SUBJECT: Forwards revised response to Question 410.10 re handling of light loads. Probability of unacceptable consequences resulting from drop of light load over open reactor vessel is very low.

St. Lucie Unit 2
Response to NRC Question 410.10
Light Loads

Question 410.10:

Figure 1

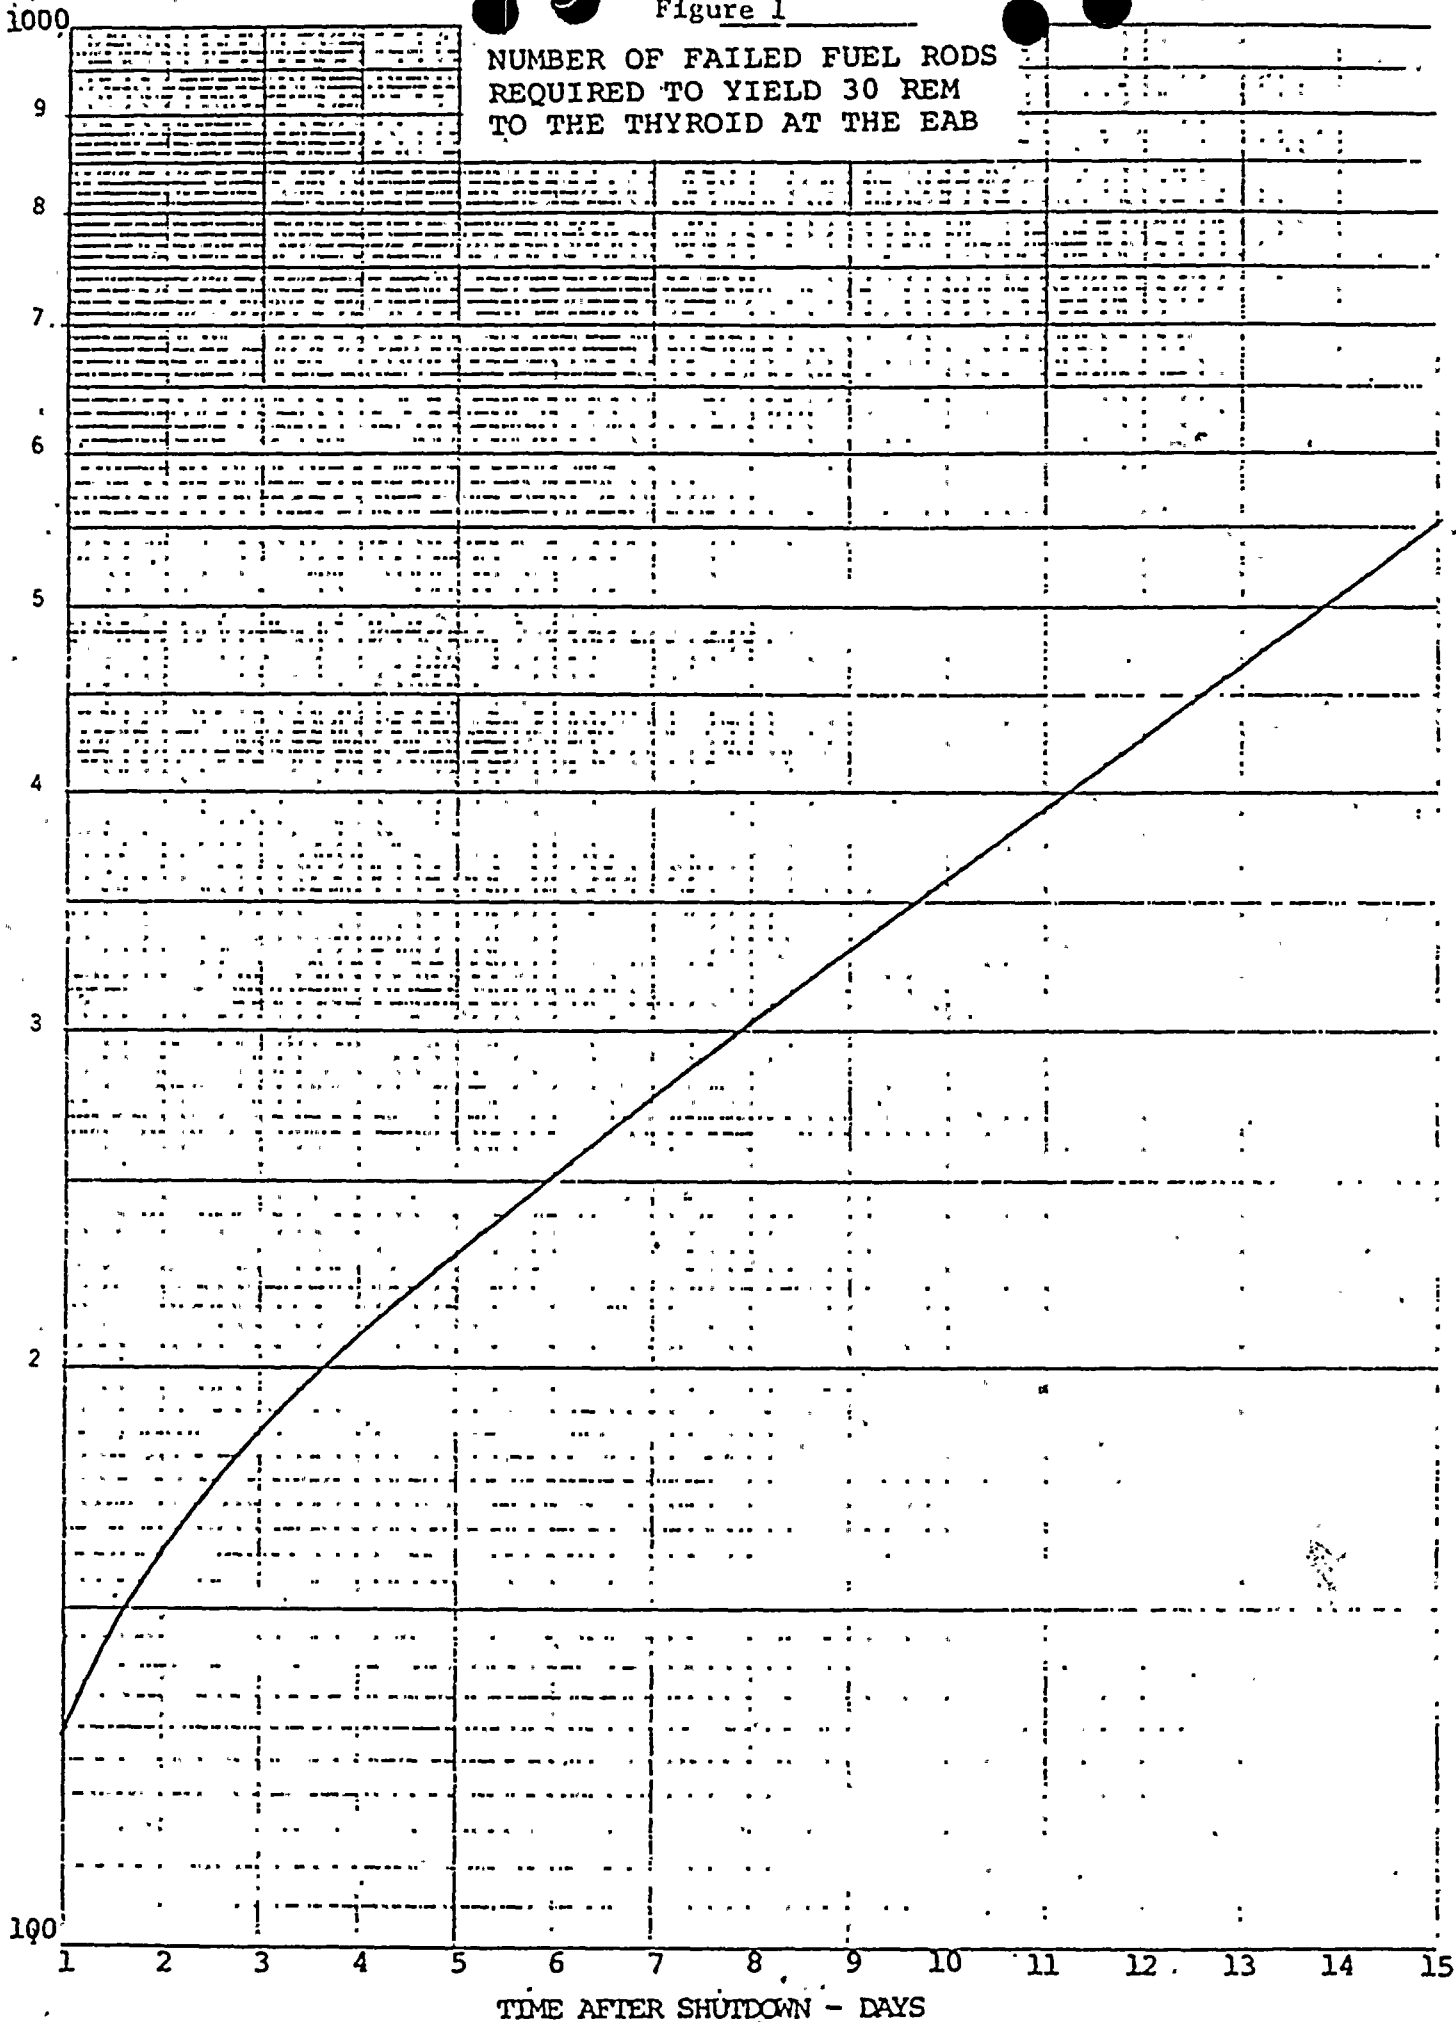
Describe, discuss and verify that the maximum potential kinetic energy contained in all objects of less weight than a spent fuel assembly which will be handled over spent fuel will not exceed the effects of the fuel handling accident in section 15.7.4 of the FSAR.

Rather than embarking on a very lengthy and state-of-the-art calculation to assess the precise damage that might be caused by dropped light loads, a simplified calculation was performed that indicated the number of fuel pins that could be damaged and not cause the site boundary dose to exceed a small part of 10 CFR 100 limits. The number of pins to cause site limits to be reached is dependent on the decay time allowed prior to release. The results of this calculation can be shown in Figure 1. As indicated on the figure, it will take only 6 days of decay to allow a release from one entire assembly without exceeding a small fraction of site limits. The time of decay is quite significant to this light loads concern. First, available gas curie content per pin decreases with time; i.e., the fission gas decay. Second, the minimum time that must pass before the fuel in the reactor is exposed to potential drop damage is several days. To date, the reactor vessel head and upper

guide structure has not been removed in less than 10 days; and this corresponds to decay time of sufficient duration to maintain site boundary limits even if 360 pins are damaged. As can be seen from these values, this corresponds to significant damage to 1.41 fuel assemblies. Therefore, from a qualitative standpoint, it is apparent that a dropped light load would need to cause considerable damage before any site boundary limits are exceeded.
